**Proposed Temporary Private Vehicle Park (Private Cars) for a Period of 3 Years in
“Village Type Development” Zone, Lot Nos. 537 (Part), 538 (Part), 540 S.A (Part)
and 541 S.A (Part) in D.D. 218, Ma Kwu Lam Village, Sai Kung North, New Territories
(Application No. A/NE-SSH/155)**

Further Information for Planning Application Nos. A/NE-SSH/155&156**Response-to-Comment****Comments from Drainage Services Department received on 28.3.2024**

Further Information (4) for Planning Application Nos. A/NE-SSH/155**Response-to-Comment****Comments from Drainage Services Department received on 31.5.2024**

1:250 (A3)	Drainage Proposal Lots 537(part), 538(part), 540 S.A(part) and 541 S.A(part) in D.D.218 Ma Kwu Lam, Sai Kung North, N.T	Goldrich Planners & Surveyors Ltd.
April 2024		Plan 4.1 (P 23055B)

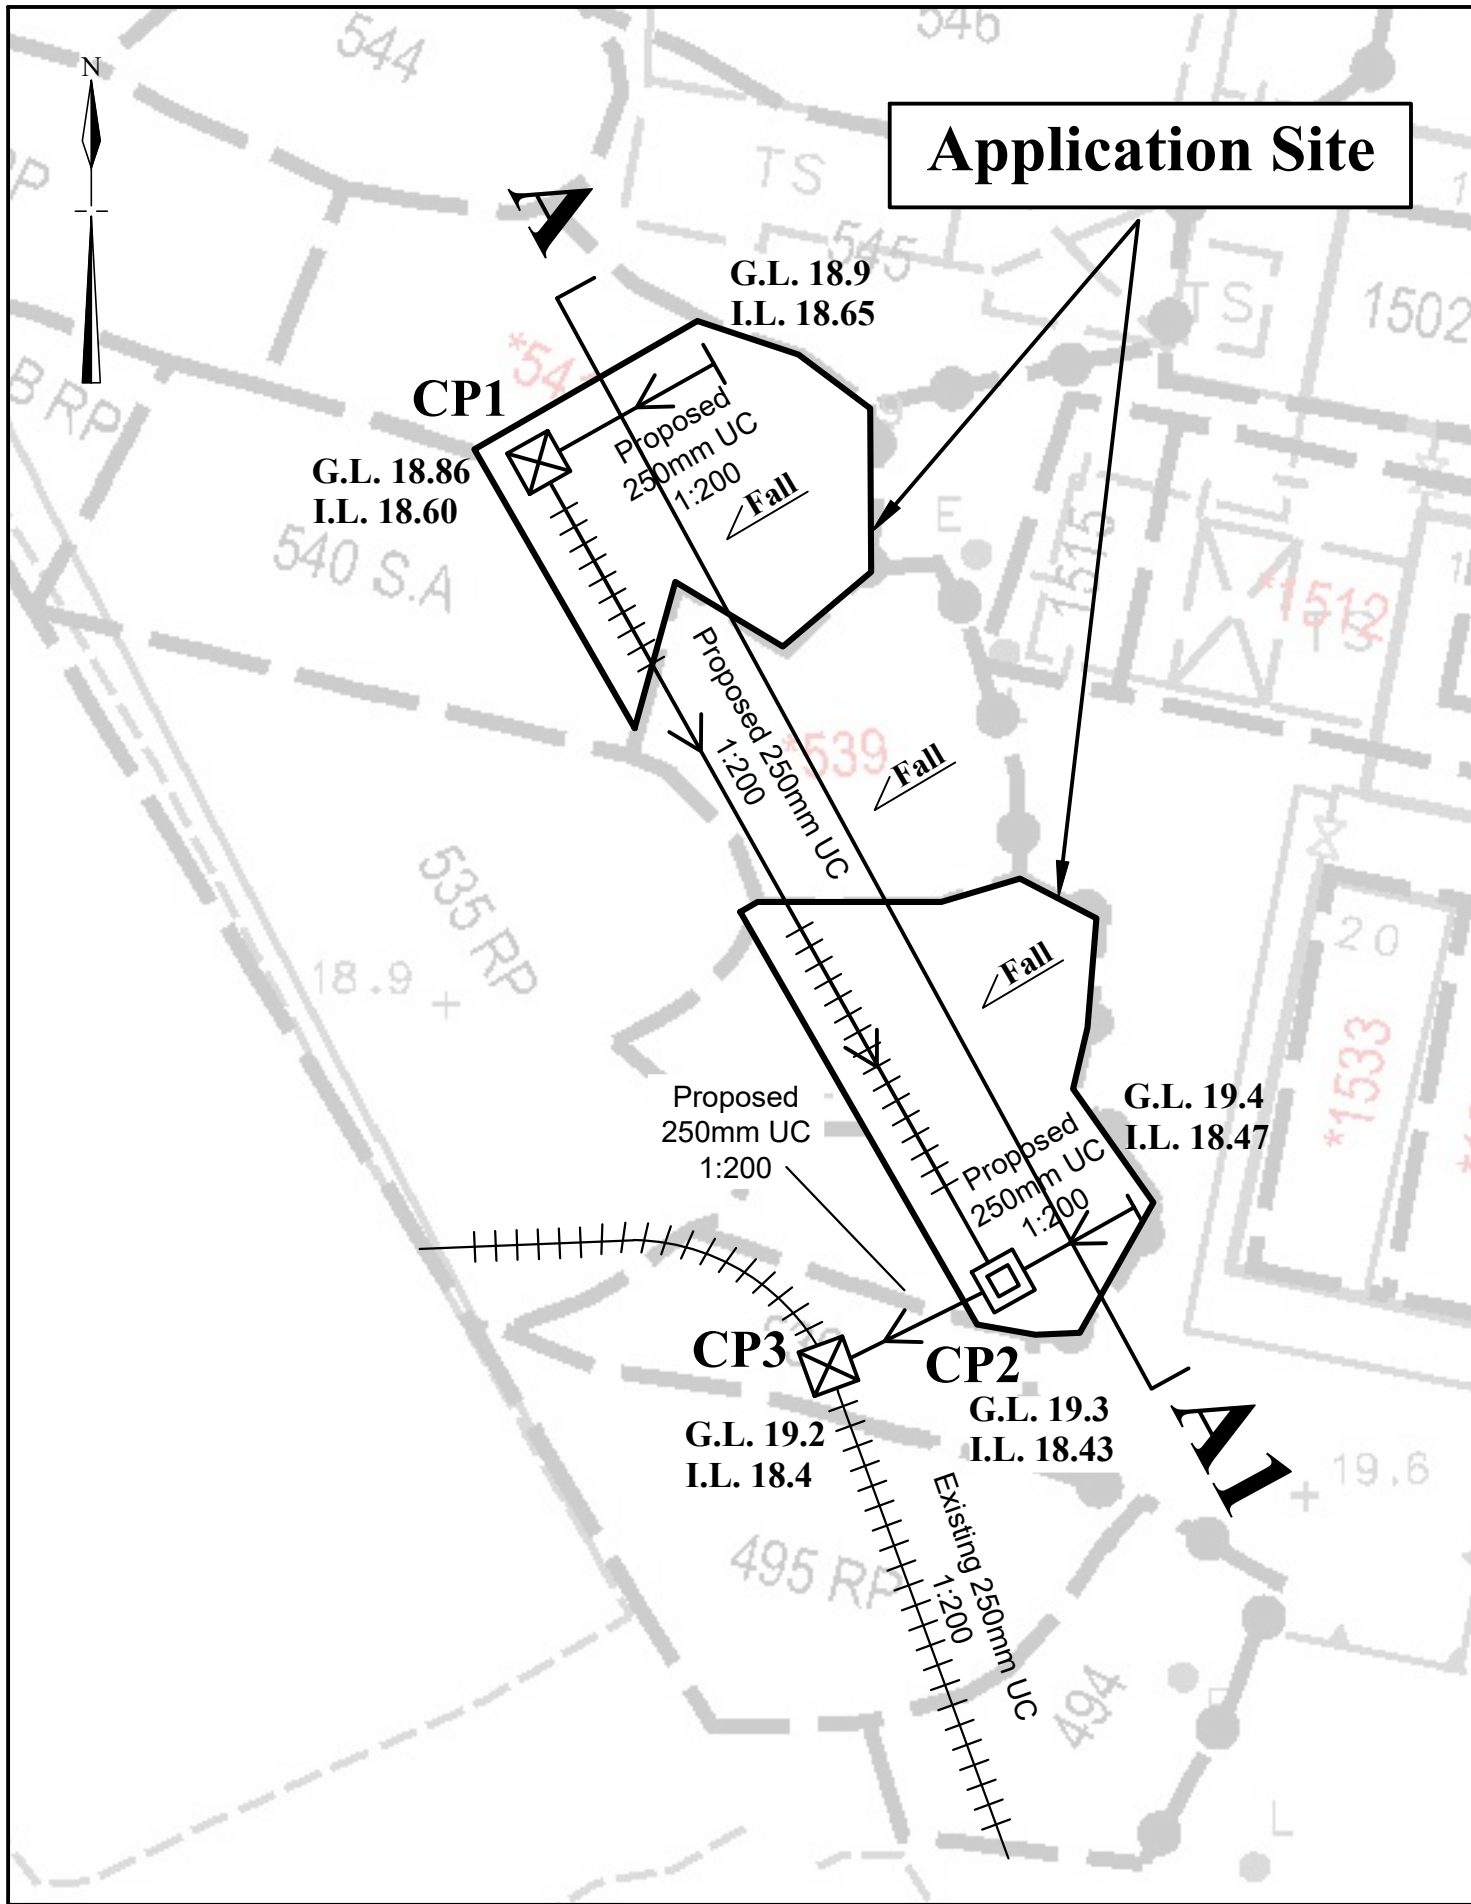
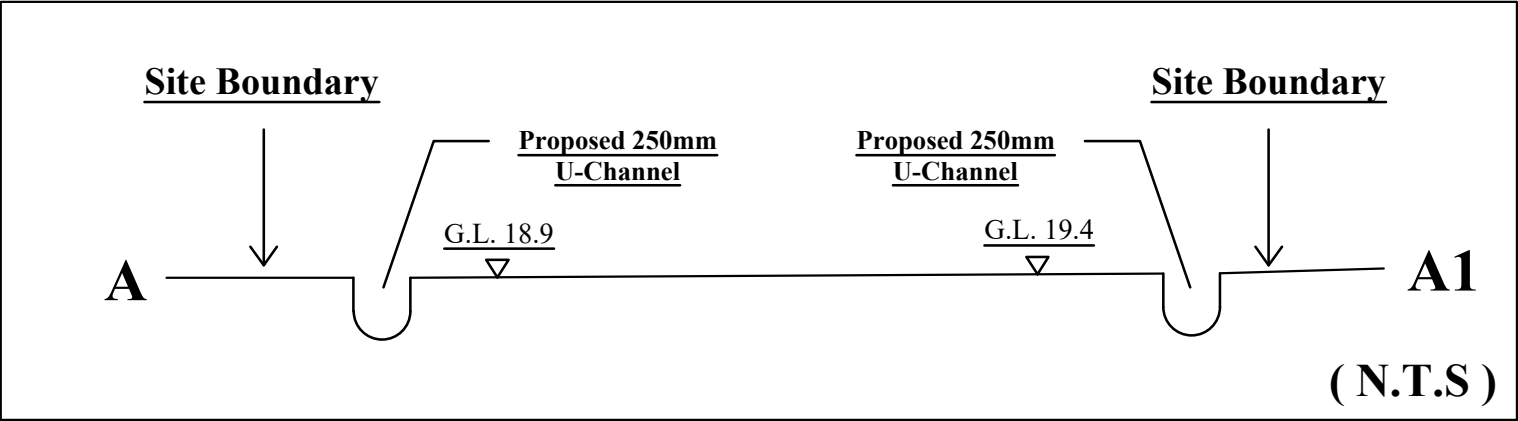
I.	Comment	Response
1.	Proposed finished site formation level and footprint of the proposed development (bearing in mind that the site formation level shall not cause flooding risk to nearby area/premises).	<p>For application no. A/NE-SSH/155, the Site had been formed and the existing formation levels range from +18.9 to +19.4 mPD.</p> <p>For application no. A/NE-SSH/156, the Site had been formed and the existing formation level is at +17.8 mPD.</p> <p>It is anticipated that the Proposed Development shall not impose flooding risks to the surrounding areas with the provision of the proposed drainage facilities (see enclosed drainage proposals of both applications).</p>

2.	Stormwater drainage proposal demonstrating stormwater drainage collection and disposal facilities of adequate flow capacity already exist/to be provided can deal with surface runoff within the lot or flow from adjacent areas including overland flow. The lot owner(s) shall effect the necessary modification/upgrading work of downstream drainage system.	<p>For application no. A/NE-SSH/155, please refer to the enclosed drainage proposal at Plans 4.1 & 4.2.</p> <p>For application no. A/NE-SSH/156, please refer to the enclosed drainage proposal at Plans 6.1 & 6.2.</p>

1:300 (A3)	Drainage Proposal Lots 537(part), 538(part), 540 S.A(part) and 541 S.A(part) in D.D.218 Ma Kwu Lam, Sai Kung North, N.T	Goldrich Planners & Surveyors Ltd.
April 2024		Plan 4.1a (P 23055B)

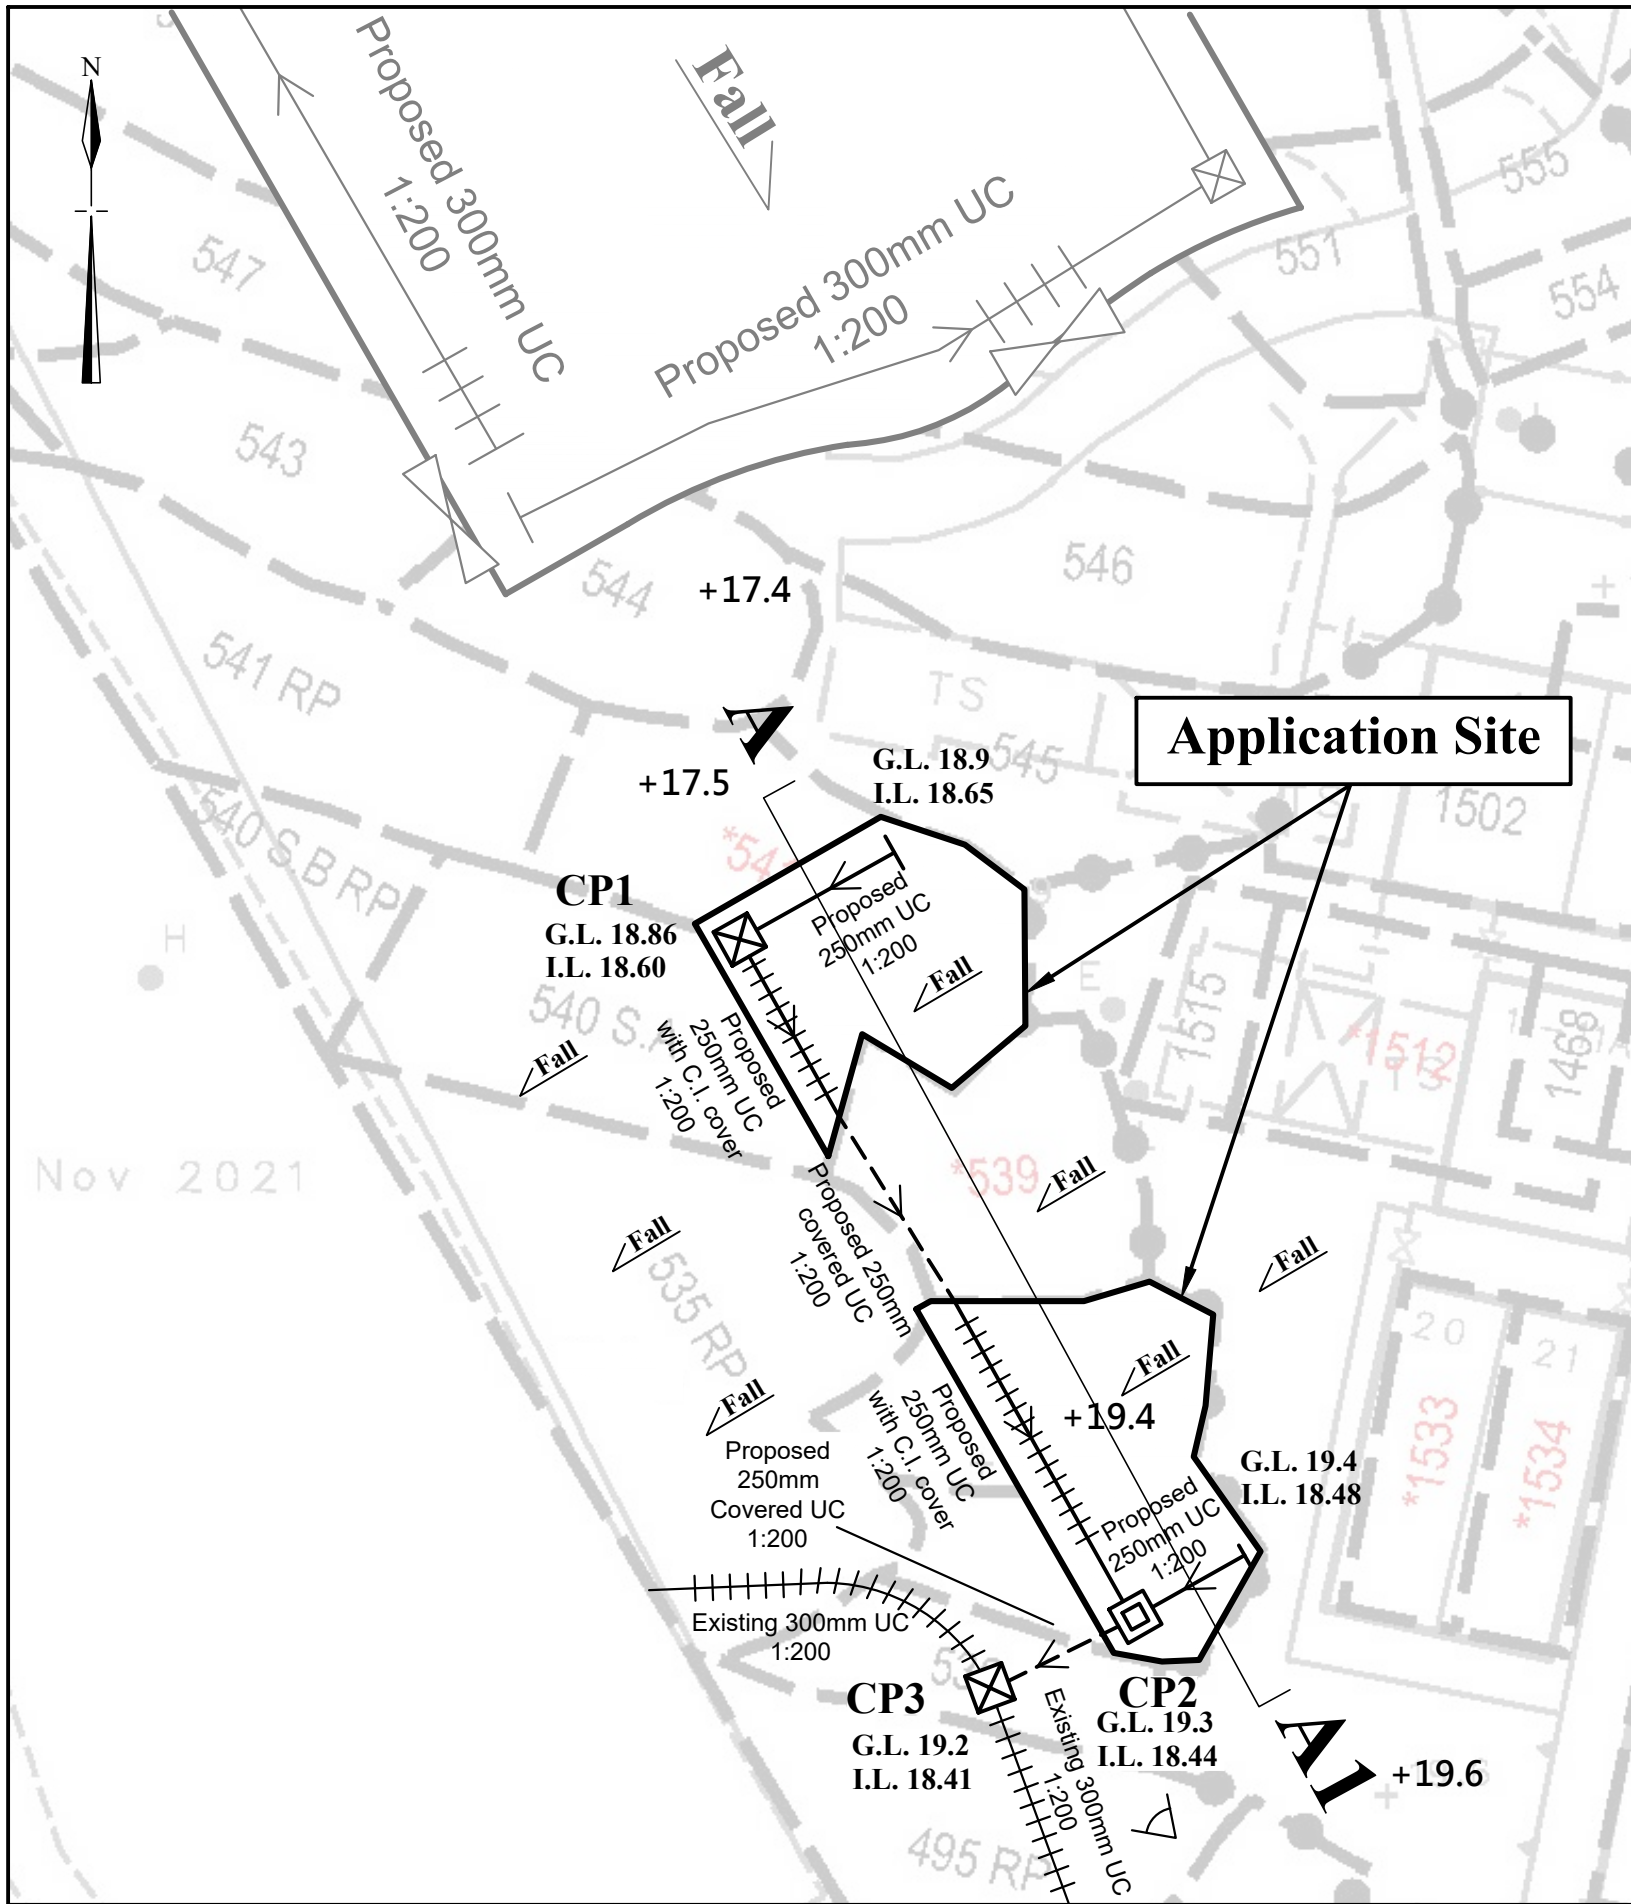
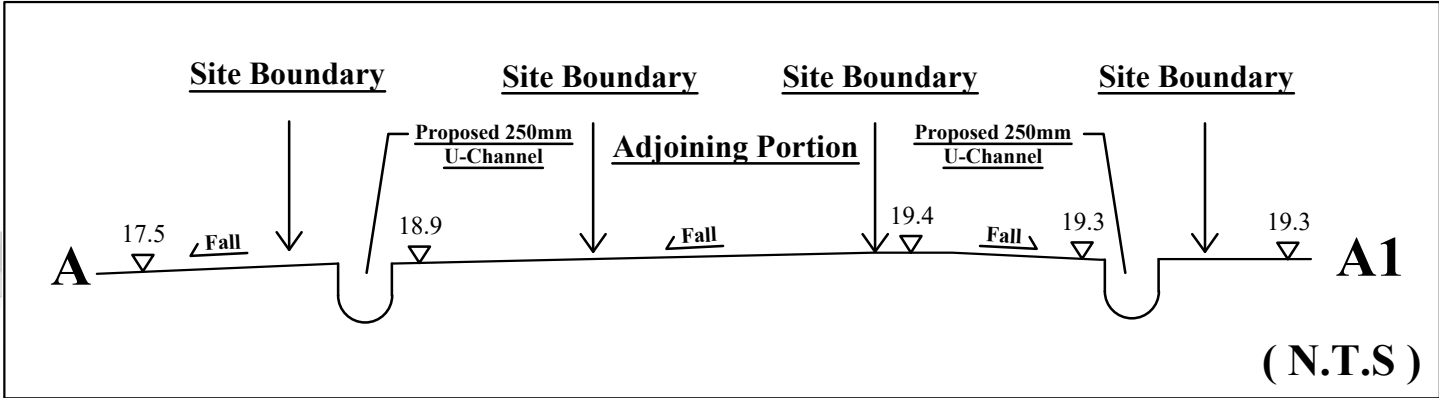
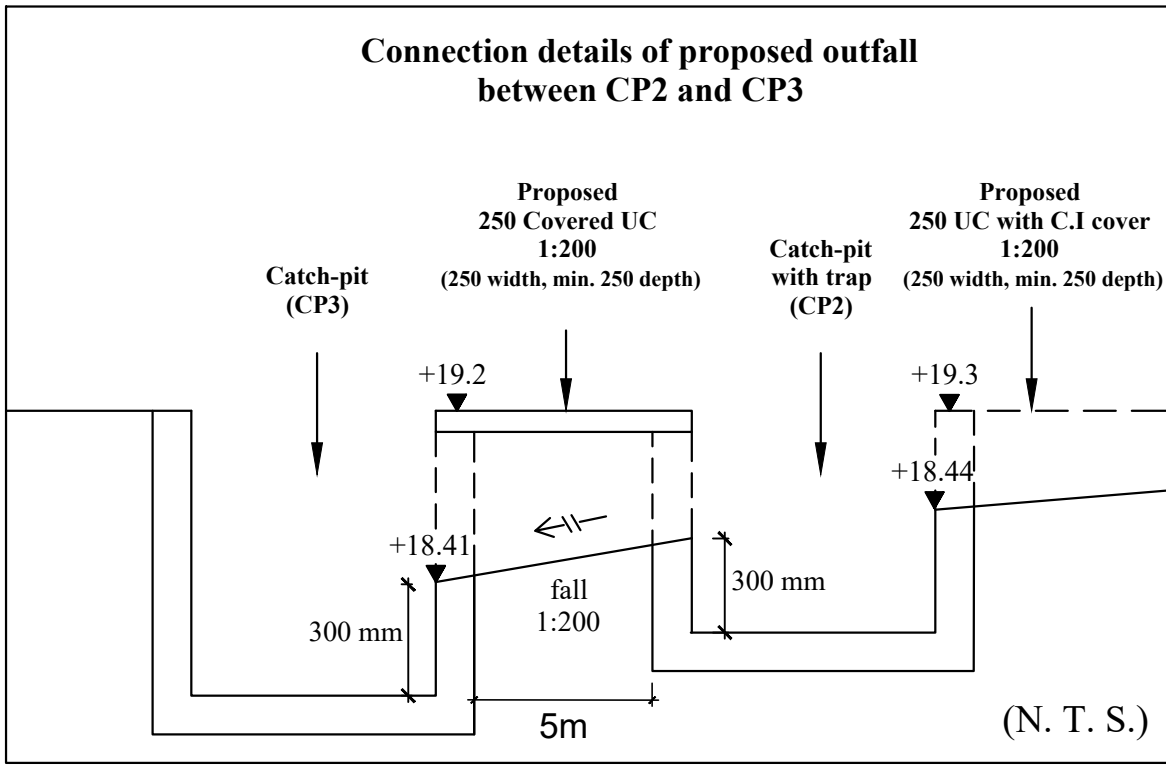
I.	Comment	Response
(a)	Supporting calculations to demonstrate that the proposed drainage system and the existing downstream drain/channel has adequate capacity to convey the runoff to be discharged arising from the proposed development. (Checking for existing 250UC and its downstream for SSH_155)	Please refer to attached drainage calculations for details.

(c)	The drainage flow path from the development to the public drainage system / streamcourse / sea / any recognized drainage facilities should be provided in association with supporting site photos for the captioned submission. (Please provide downstream information of existing 250UC for SSH_155).	Please refer to the attached site photo showing the drainage flow path to local village drainage facilities.
